City of Cambridge

Re: City of Cambridge Comments on Final EIR for EF Education First Expansion

City of Cambridge
Comments on Final Environmental Impact Report
EF Education First Expansion at North Point
EEA No. 15293

Figure 3.1
LEED Checklist

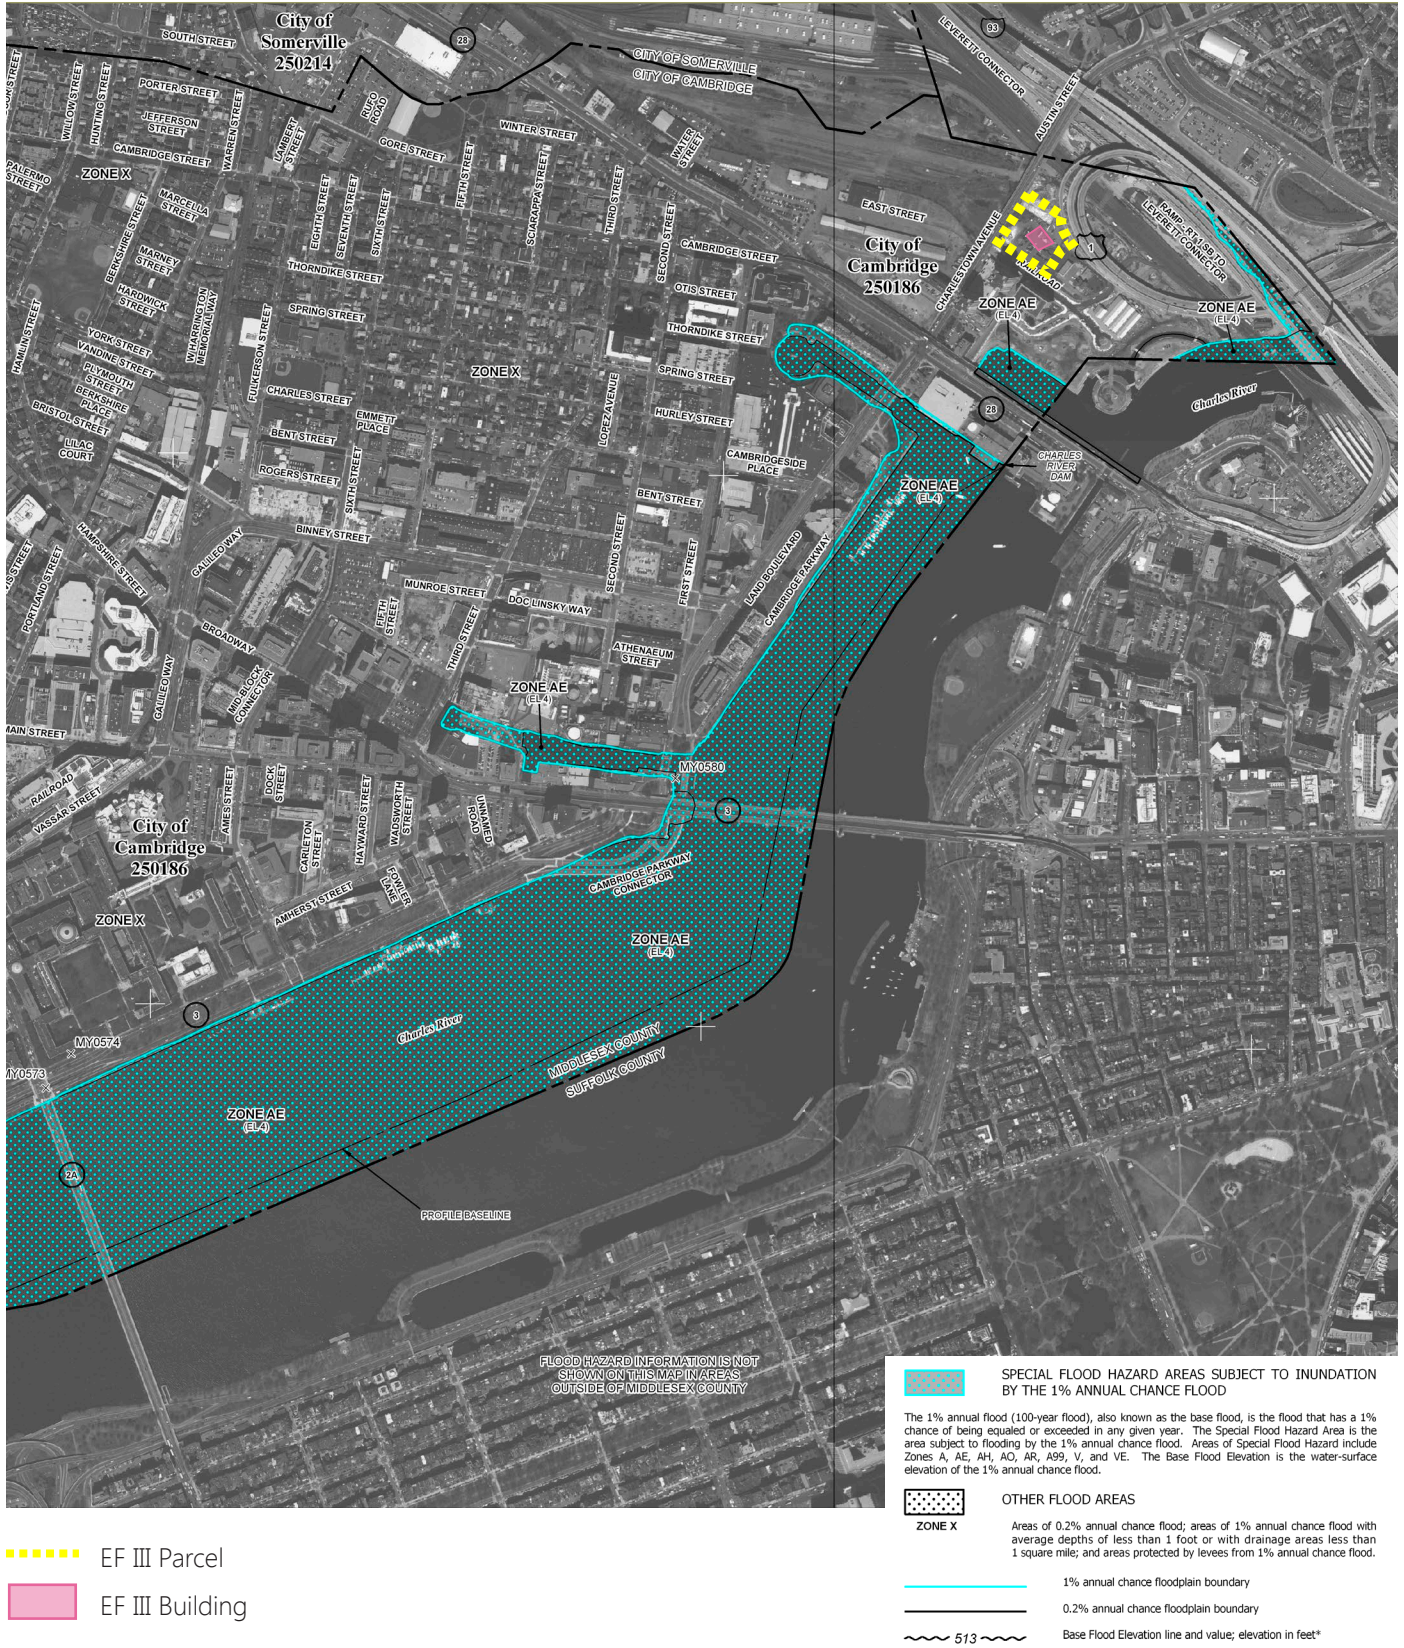
When the Final EIR was published, the project was designed to achieve LEED Silver. Since then, the EF Project Team has expressed that LEED Gold is achievable and is now the target, with a projected 62 points and an additional 10 points listed as "likely". At this point, the EF III project is on track to meet, at minimum, its projected certification level and point total.

The DEIR indicates the project is aiming for certifiability at the LEED Silver level. This is a very modest goal. The City is currently working toward amending the Zoning Ordinance to require LEED Gold for projects needing special permits. The Net Zero Action Plan adopted by the City in 2015 recommends that new development meet LEED Gold and achieve a minimum of 6 energy points and this standard is being met by other projects currently going through permitting in Cambridge.

The Project is on track to meet definitively LEED-NC v4 Silver Certifiable. As demonstrated by the draft LEED Scorecard provided in Figure 3.1, a total of 50 “Yes” points have been determined, and 17 “Likely” points are being targeted. As indicated earlier, EF is devoted to constructing a sustainable building that will be LEED Silver certifiable with points likely beyond LEED Silver in an effort to make improvements that create steps towards LEED Gold.
